Outgoing
CO410002
OK**OGMCOAL - SUFCO Mine 4th Quarter 2009 Water Quality Report**

WATER QUALITY MEMORANDUM

RE: 2009 Fourth Quarter Water Monitoring, Canyon Fuel Company, LLC, SUFCO Mine, C/041/0002, WQ09-4, Task ID #3443

Groundwater Elevation for Well 01-8-1

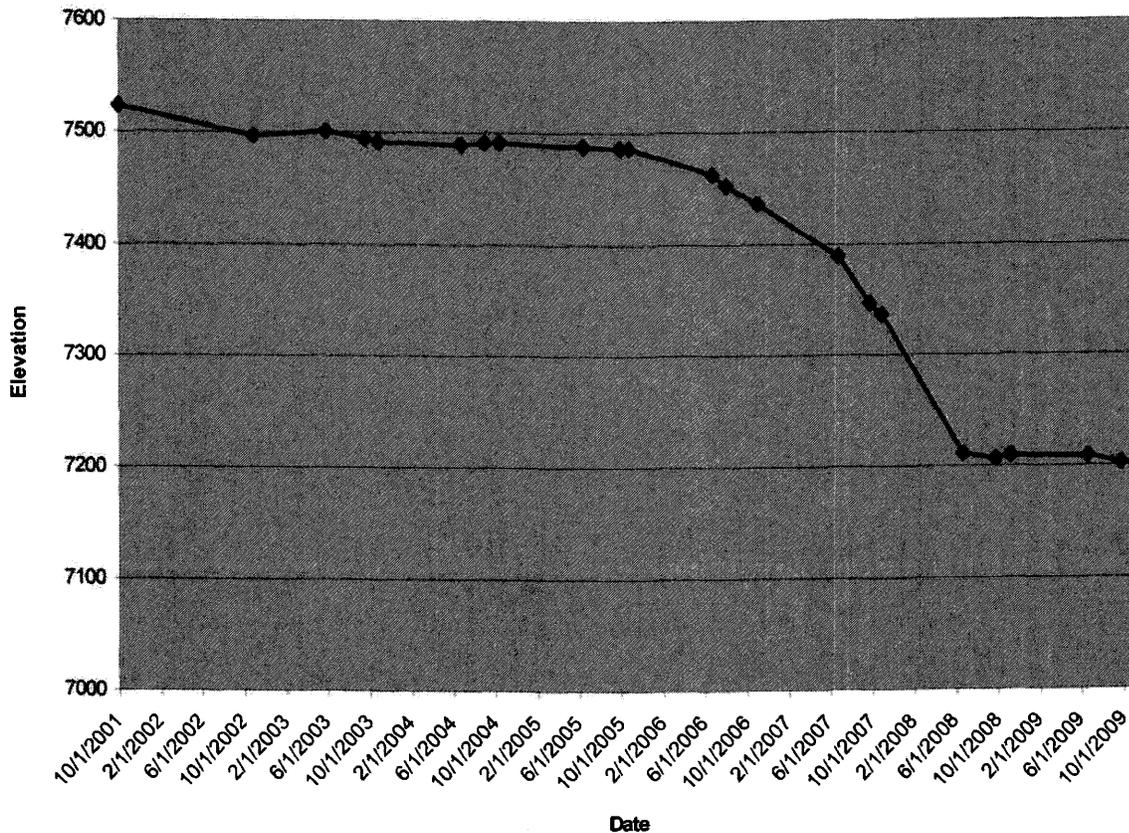
The Permittee submitted all required samples for the wells. Groundwater elevations for well 01-08-1 have been submitted since 2001 monitoring the groundwater in the SITLA Muddy Lease tract. As can be seen in the chart, there was a decline in groundwater elevations of approximately 275 feet evident from the period between October 2005 and June 2008 while this area was being actively mined. Groundwater levels have begun to stabilize but it is not apparent as of yet if groundwater elevations will rebound to pre-mining levels.
